ADDENDUM No. 2

ITB No. 4561

WTP LIME RESIDUAL REMOVAL CONTRACT No. 2 – DREDGING AND HAULING

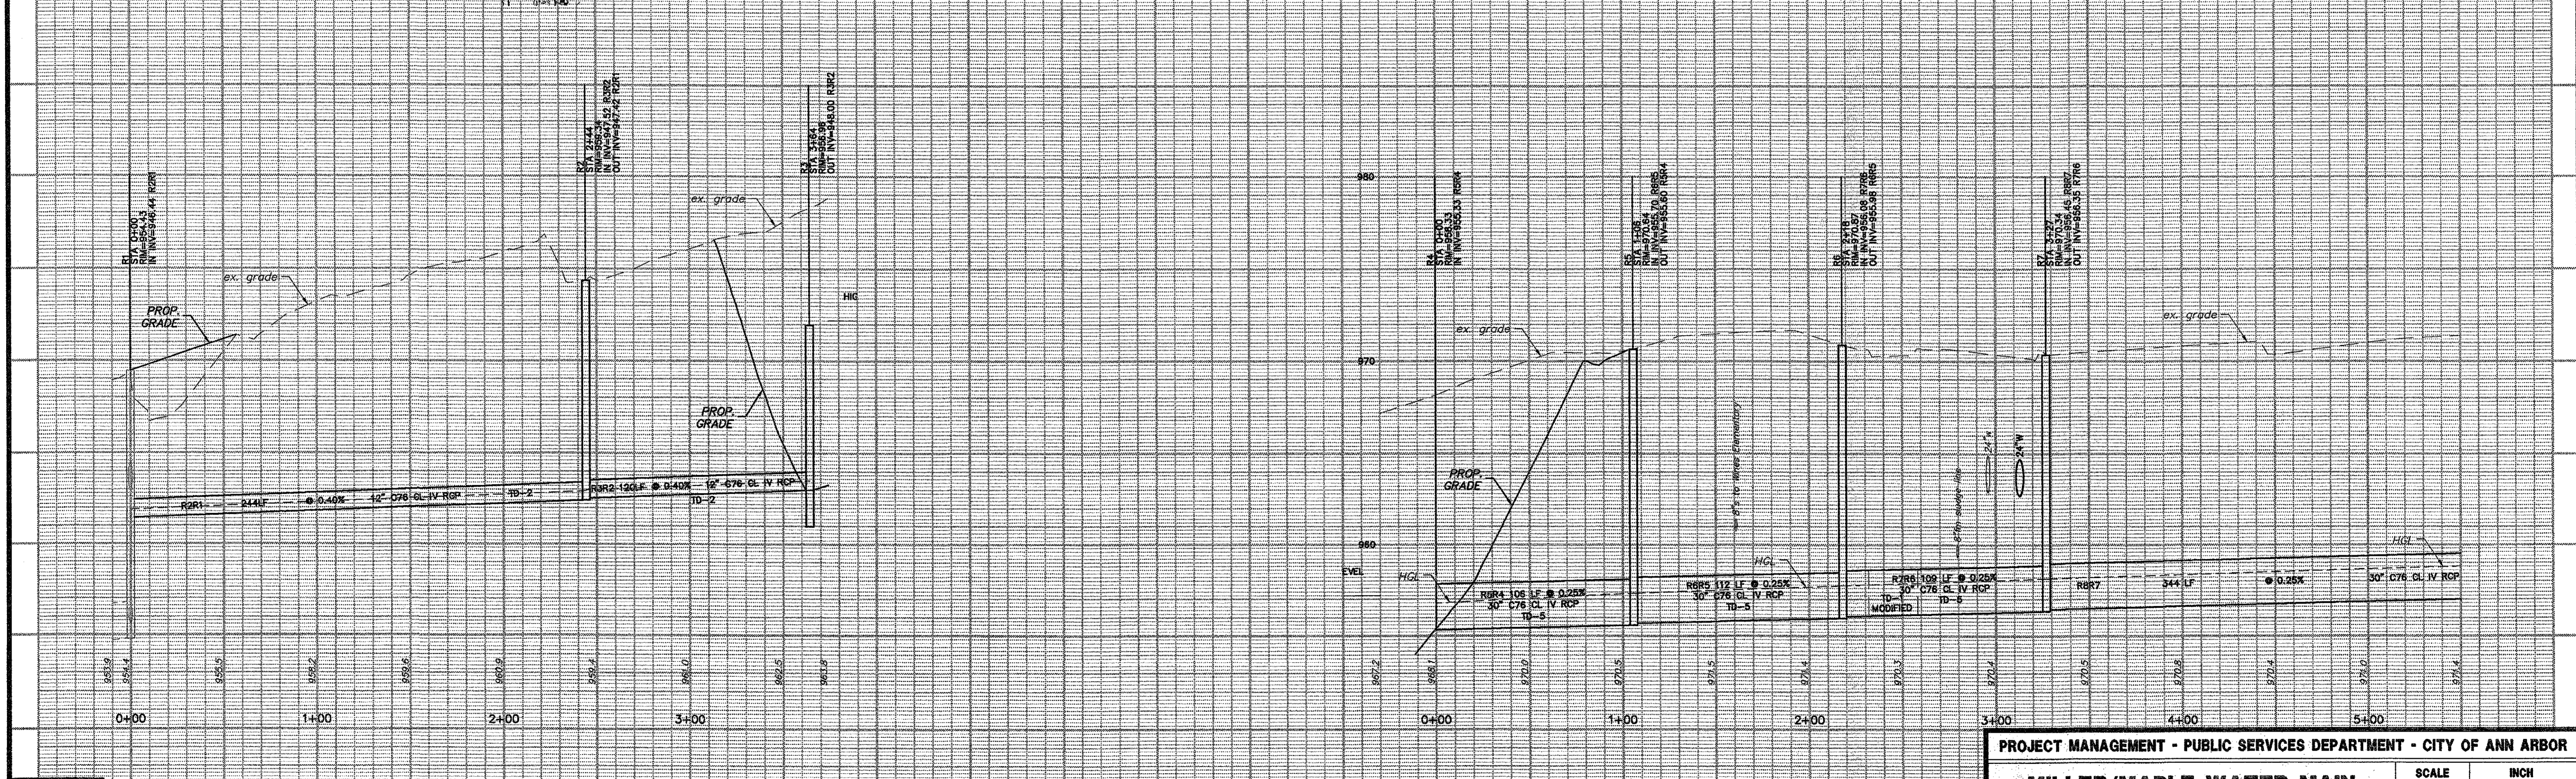
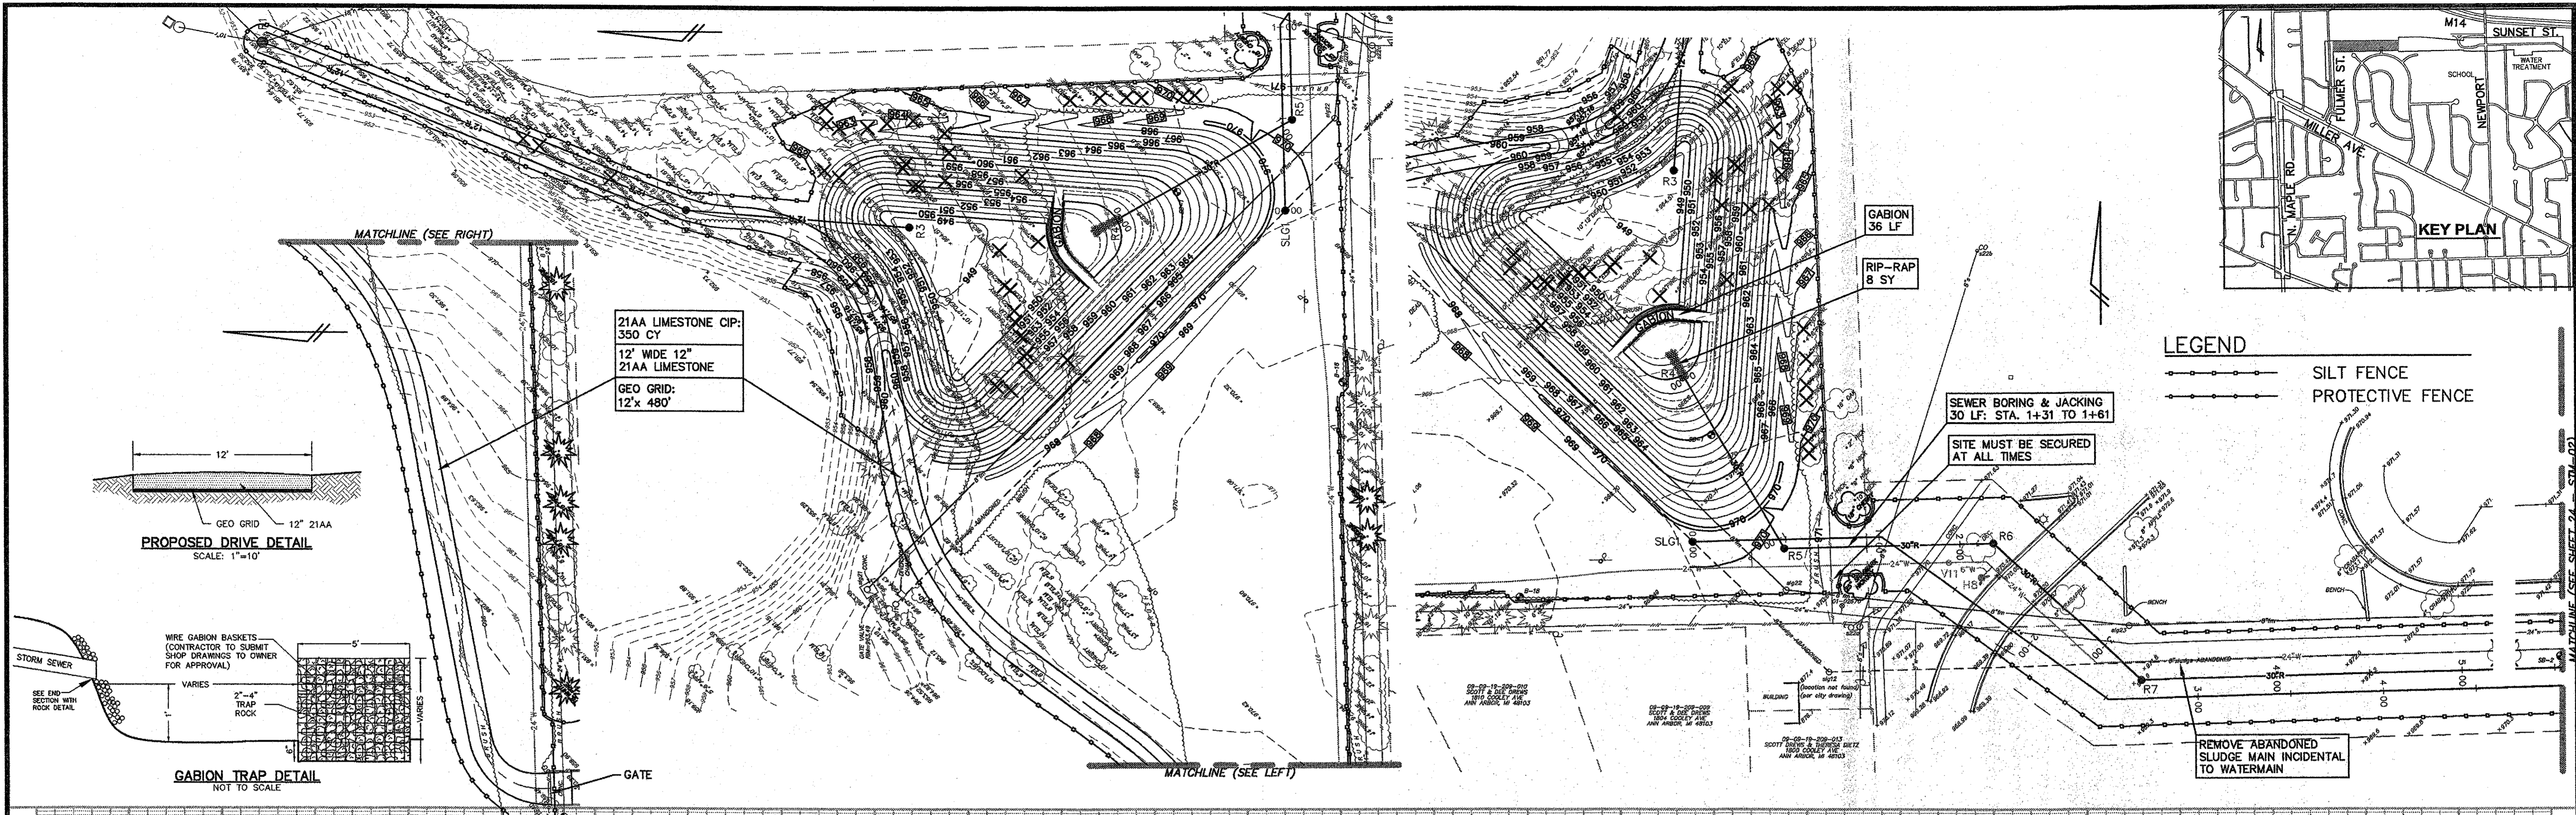
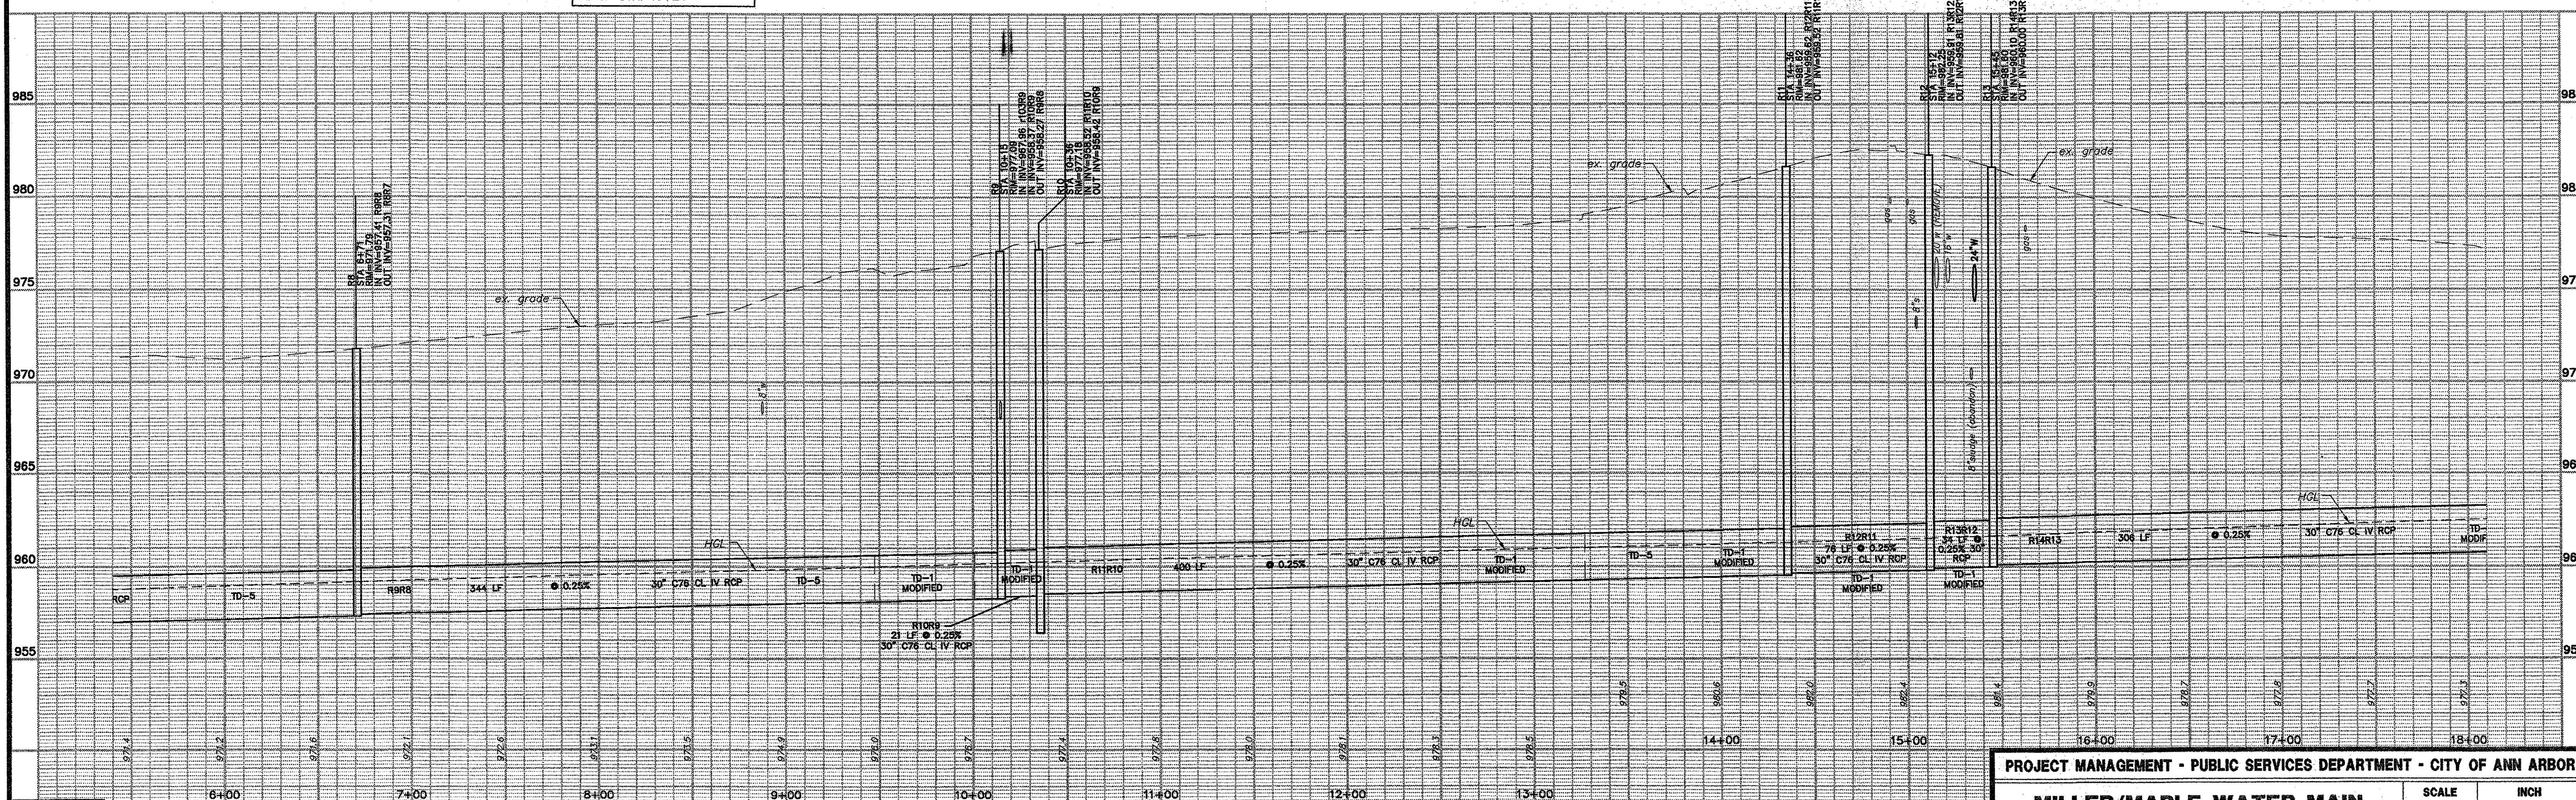
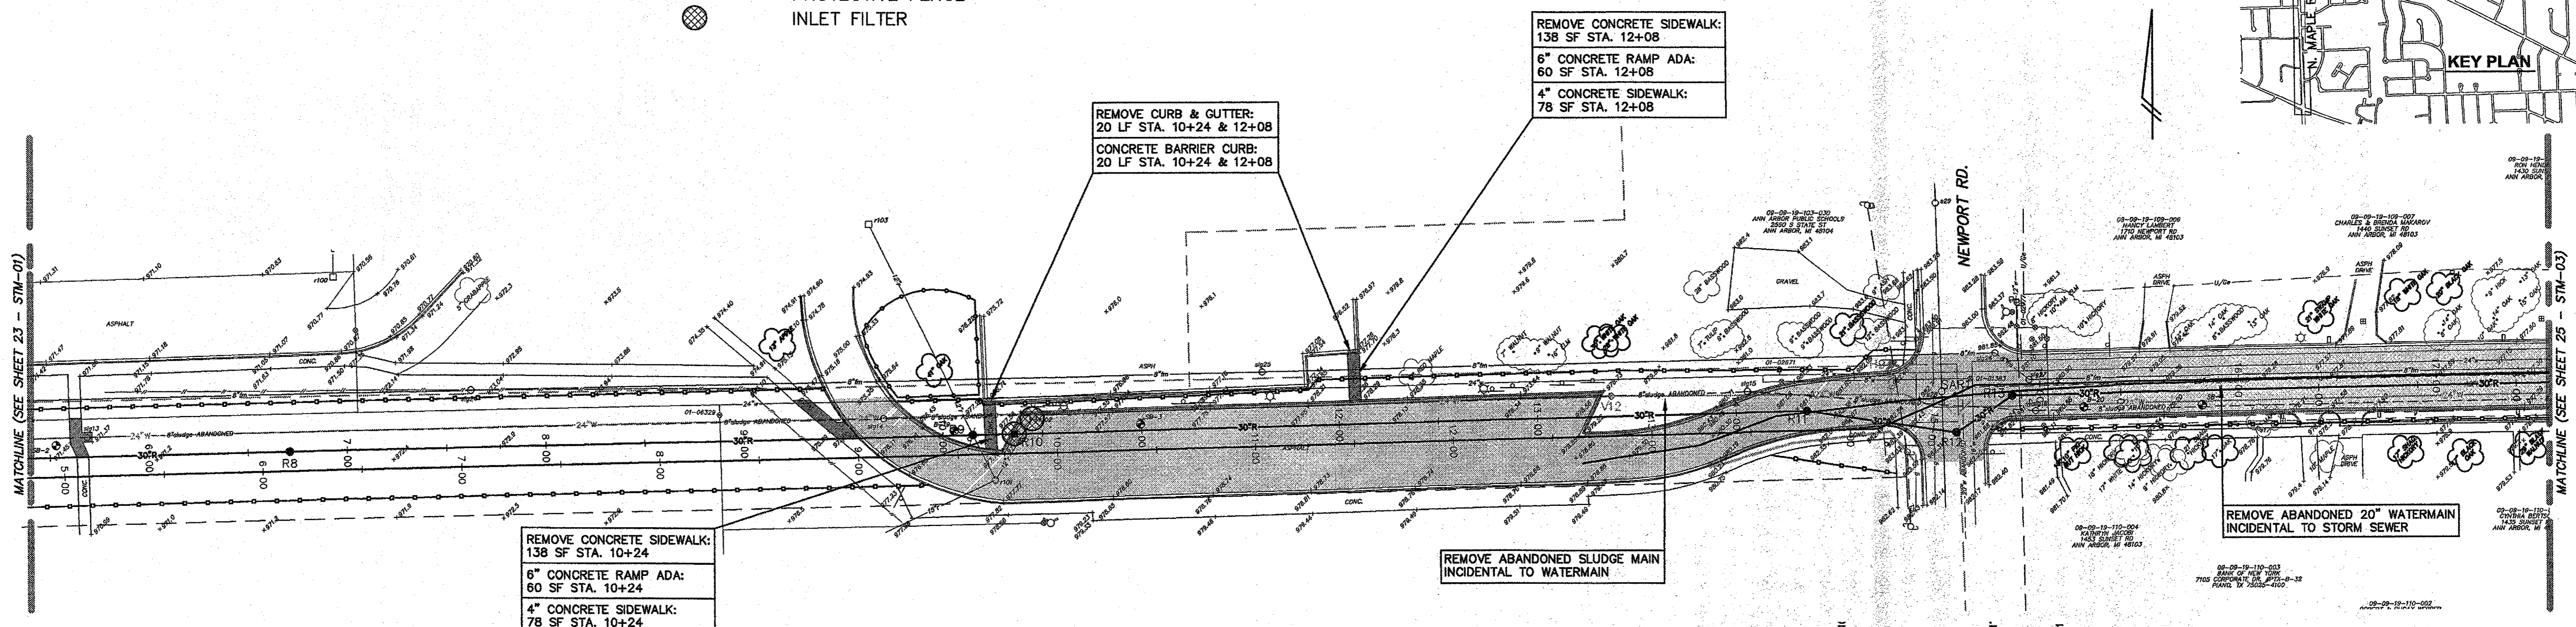
Q: Please provide the carrying capacity of the existing line that will be used to return the filtrate water back to the lagoon.

A: See attached record drawings of the 30-inch storm sewer. (3 pages)
